TRANS/WP.29/913  
17 April 2003

DRAFT SUPPLEMENT 8 TO THE 03 SERIES  
OF AMENDMENTS TO REGULATION No. 36

(Large capacity passenger vehicles)

"Figure 10

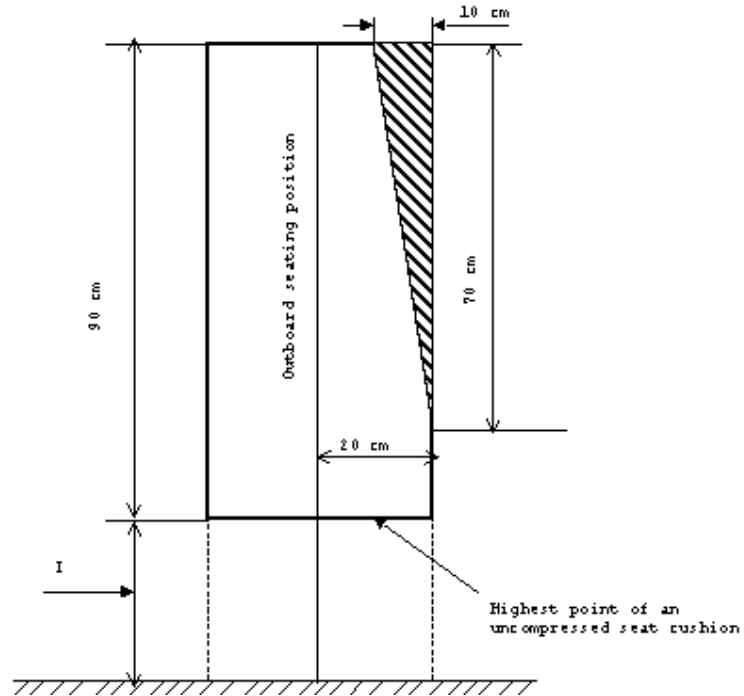
"5.7.8.6.2.2. Intrusion of a structural member provided that the intrusion is included within a triangle whose peak is situated 70 cm from the top and whose base is 10 cm in width and situated in the upper part of the space in question, adjacent to the side wall of the vehicle (see annex 3, figure 10);"

Annex 3, Figure 10, amend to read:
